ALTERATION TO A HISTORIC PROPERTY STAFF REPORT

Site: 24 Warren Avenue Case: HPC 2018.085

<u>Petition:</u> William Doyle, Owner seeks permission from the Somerville Historic Preservation Commission (HPC) to repair porches using mixed materials

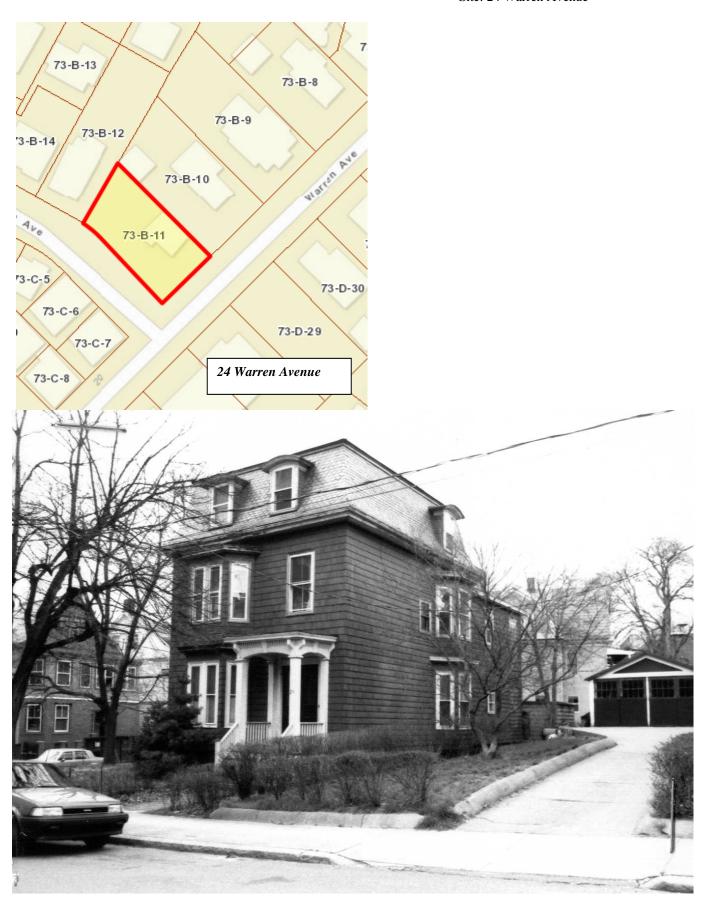
<u>Staff Findings</u>: Staff finds that the proposed alterations will minimally affect the perception of the existing building. The most visible portions of the porches will be returned to wood and will retain the historic character. The distance from the street will eliminate the obvious alterations of decking materials. The wrapped and detailed posts will blend with the design of the other mansards on the street.

- 3. The front porch shall be returned to its previous details with wood porch rails, balusters, posts and skirts. (C/NA)
- 4. The rear porch posts, rails and balusters shall match the previously existing front porch. (C/NA)

- 5. The porches shall be rebuilt using Trex® floor boards and AZEK® risers (C/A)
- 6. All porch posts shall be wrapped in AZEK® to meet the original dimensions and design. (C/NA)

- 7. The porch skirt shall be made of a vertical or diagonal wood lattice. (C/NA)
- 8. Historic Staff shall issue a sign-off upon completion of the project that it was executed in accordance with this Certificate and approved plans.
